MEMORANDUM

To: Planning Commission
From: Community Development Department
Subject: Centennial Towers –Master Plan Review and Phase 1 SPR-06-18-5420
Preliminary Site Plan Review 4.27 Acres
215 W. Sego Lily Drive, Community #9 CBD-A&C Zone

① PHASE 1
RESIDENTIAL TOWER
RESTAURANT

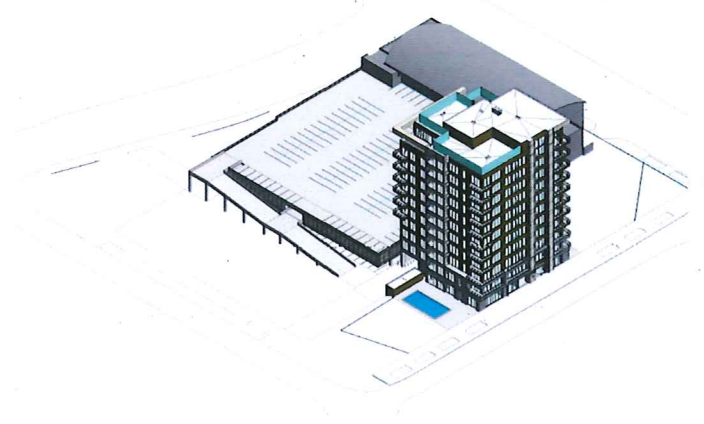
The applicant is proposing to construct a twelve (12) story residential building, with a restaurant and amenity space on the street level in phase 1. This building has been reviewed by the Architectural Review Committee and received a positive recommendation on their proposed building design after several meetings and iterations on the design to help achieve the code requirements of having a brick, polished granite, or stone base, with a defined middle, and top. The applicant is proposing two different base material options that the Committee reviewed, a black or brown granite base. The rest of the building consists of composite and aluminum siding

5. **Screening of Mechanical.** Building 2’s elevations show unscreened mechanical equipment. This needs to be fully screened with taller parapet walls or a secondary screening system.

10. That the **architectural materials** of Building 2 include: polished granite, aluma board panels and siding, and glass. That all roof mounted mechanical equipment be fully screened. The parking structure is to be approved with a temporary screen system that will be replaced upon the construction of additional levels above the existing parking decks.
